TECHNICAL NOTE

Project Title: Arundel Road

Report Reference: JNY10317-01

Access Location & Visibility

Title REVISED ACCESS LOCATION
SWEEP PATH ANALYSIS

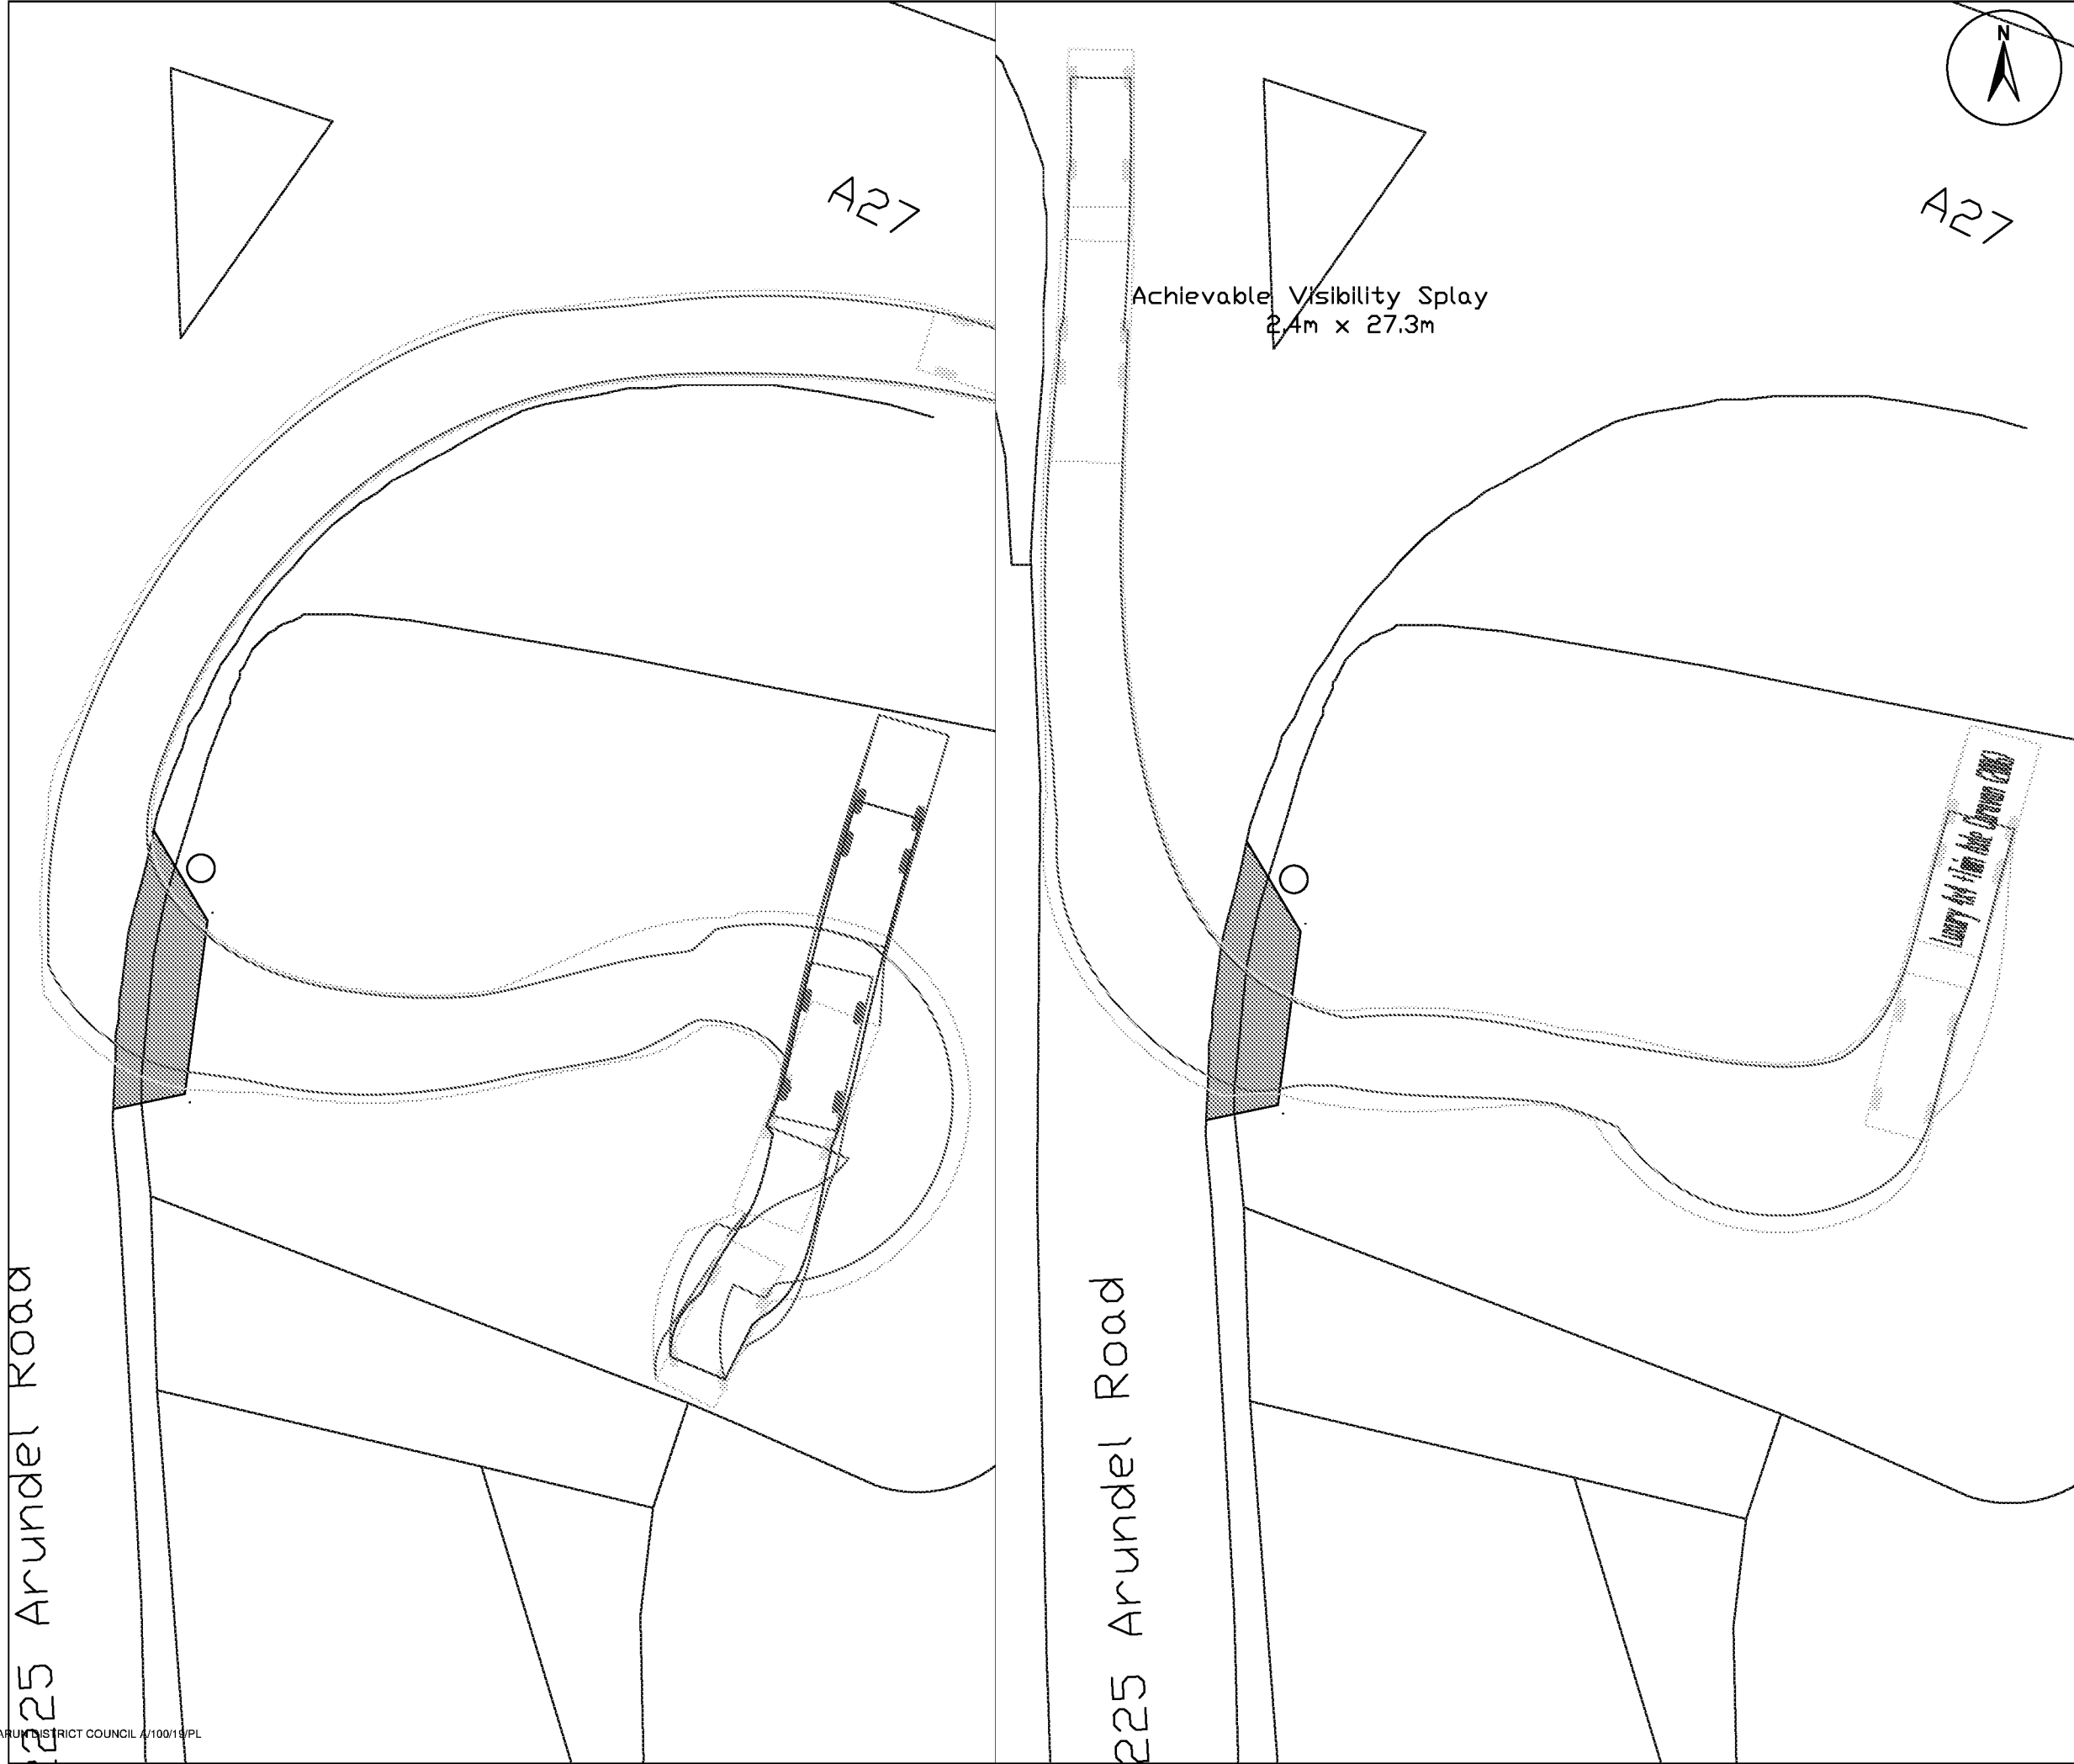
- “Whilst I accept that it might well be possible to turn vehicles within the site, the lack of visibility would mean slow-moving commercial vehicles, exiting the site with little knowledge of cars approaching from the south. This would pose an unacceptable risk to existing highway users.”

- 1.33 To demonstrate the ability of vehicle to enter the site, manoeuvre so as to be able to park a trailer and then be able to leave the site with the trailer, a series of vehicle swept paths have been undertaken. These are shown in RPS drawing JNY10317/02 and can be found in **Appendix D**. The vehicle is able to enter and depart the site using a forward gear.
